May 13, 1985

ST-HL-AE-1239

South Texas Project  
Units 1 & 2  
Docket Nos. STN 50-498, STN 50-499  
Notes from Review Meeting with  
Instrumentation & Controls Systems Branch

FAILURE MODES AND EFFECTS ANALYSES  
APPLICABLE TO STP

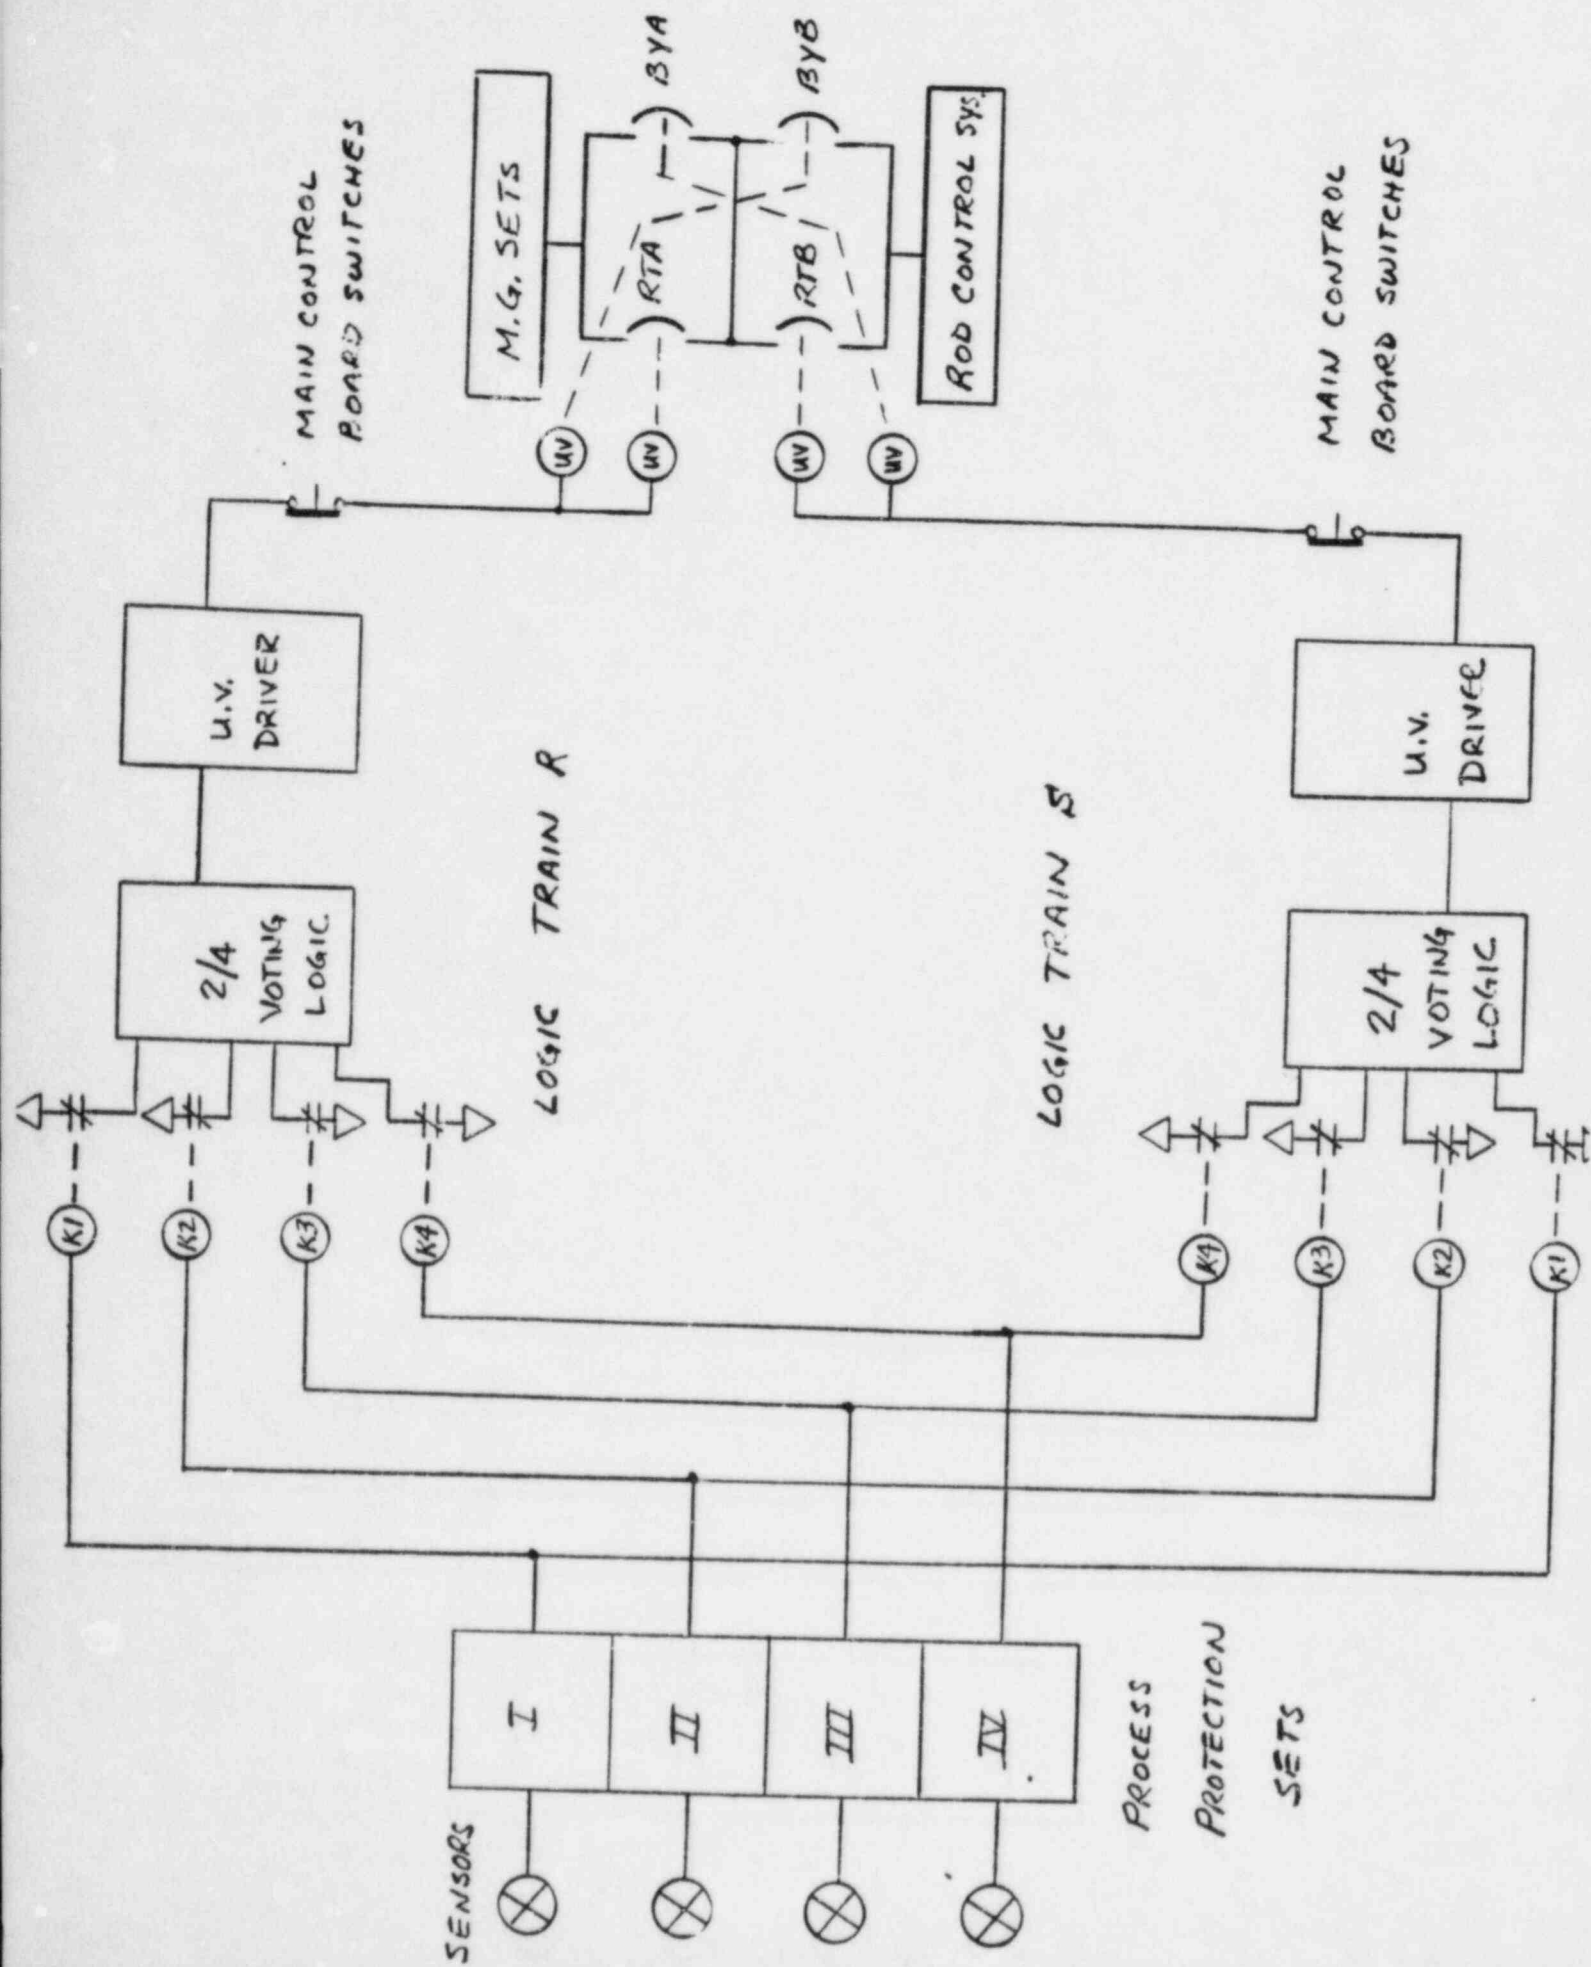
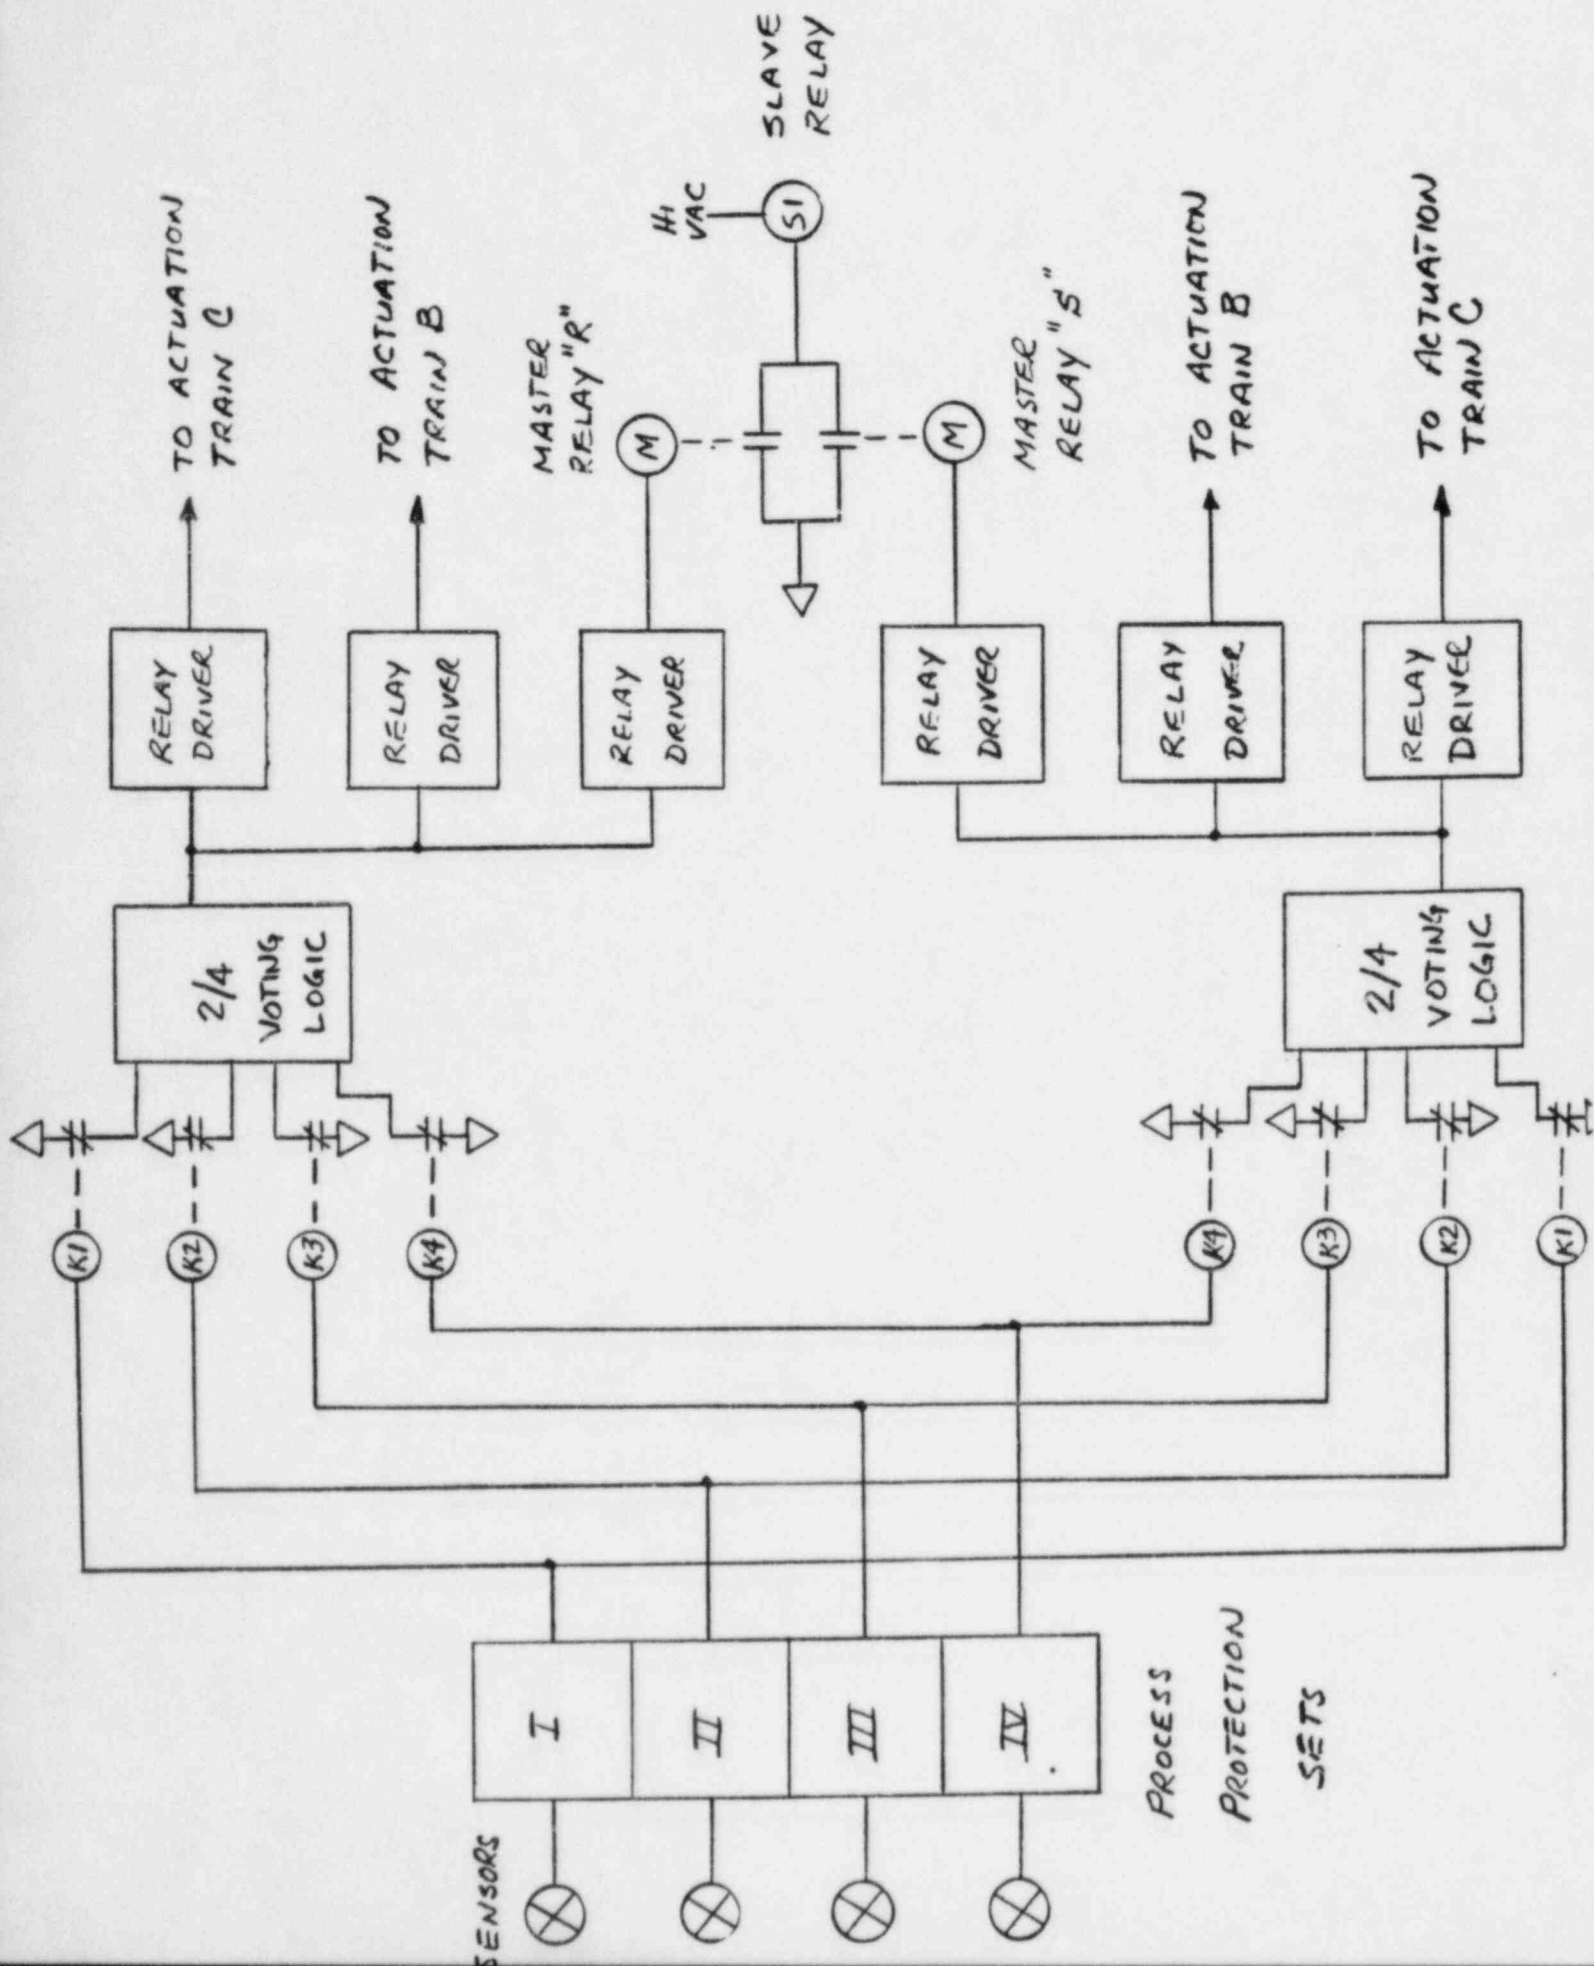
30. Provide Failure Modes and Effects Analyses on the ESFAS as  
(7.3) by R.G. 1.70 "Standard Format and Content of FSAR". Please note that the FMEA of the ESFAS should be addressed on actuation system including the NSSS & BOP scope of supply. The interfaces with power sources, instrument air system and the cooling water system to vital equipment should also be addressed. In Amendment 41 Section 7.3.2.1, there was a statement on this subject, however, in Amendment 43, that section and Tables 7.3-12, 13 and 14 were deleted. The staff finds that this further deviates from the R.G. 1.70 requirements.

Concern The ICSB raised a question concerning WCAP's on the FMEAs which relate to 2 train (not 3 train) design being applicable to STP. The NRC requested additional 3 train information.

Westinghouse subsequently addressed the question of FMEA WCAP applicability to STP. Using overviews (handout), Westinghouse reviewed the 2 train SSPS design for safeguards components and for reactor trip breakers. For STP, the reactor trip function is handled in the same way, except  $R = A$  and  $S = B$ . For safeguards components, the voting logics in R and S each drive up to 3 relay drivers, one for each actuation train (A, B and C). The relay drivers then interface with master relays, which then interface with slave relays. Reliability is improved in that testing of a logic train leaves all 3 actuation trains operable; testing of an actuation train leaves both logic trains and the other actuation trains operable.

FIGURE Q032.45-1  
SIMPLIFIED SCHEMATIC OF SOUTH TEXAS NSSS POWER DISTRIBUTION ARRANGEMENT  
(note 3)

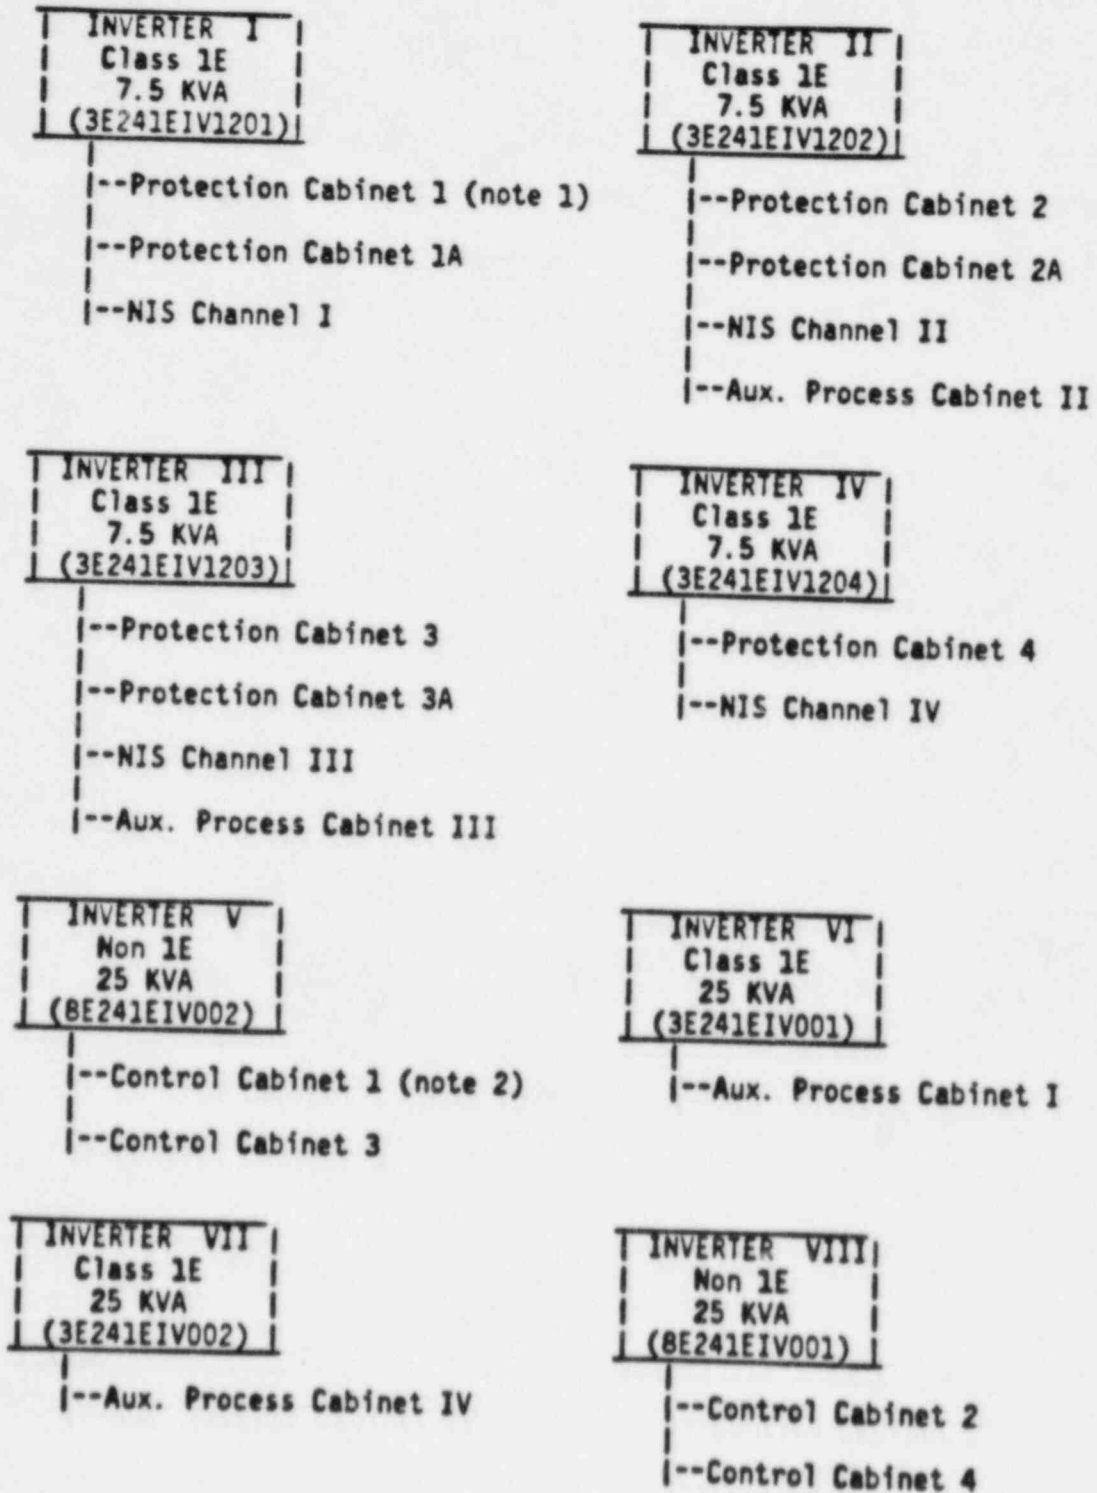
Question 032.45

To provide assurance that the design basis event analyses adequately bound other more fundamental credible failures you are requested to provide the following information:

- (1) Identify those control systems whose failure or malfunction could seriously impact plant safety.
- (2) Indicate which, if any, of the control systems identified in (1) receive power from common power sources. The power sources considered should include all power sources whose failure or malfunction could lead to failure or malfunction of more than one control system and should extend to the effects of cascading power losses due to the failure of higher level distribution panels and load centers.

The South Texas NSSS instrument power supply consists of eight instrument distribution panels receiving power through eight inverters hereafter labelled I through VIII for convenience. Figure Q032.45-1 provides a schematic of the power distribution arrangement. As shown, the instrumentation which comprises Protection Set I is housed in Protection Cabinets 1 and 1A. Similarly, the instrumentation for Protection Sets II and III is assigned to Protection Cabinets 2/2A and 3/3A respectively. Protection Set IV instrumentation resides in a single cabinet. The Control Groups are assigned to four separate cabinets powered from two non Class 1E inverters. Finally, four additional Auxiliary Process Cabinets are shown. These cabinets are part of the Qualified Display Processing System (QDPS). They are considered in this analysis because a few of the signals of interest (specifically, charging flow, pressurizer water level, and narrow range steam generator water level) are routed from the field to these cabinets first and are then passed on to the NSSS 7300 process cabinets. As indicated in the schematic, the Auxiliary Process Cabinets are aligned in a channel oriented manner corresponding to the associated protection channels so as to maintain separation; the signal channels are assigned and routed accordingly.
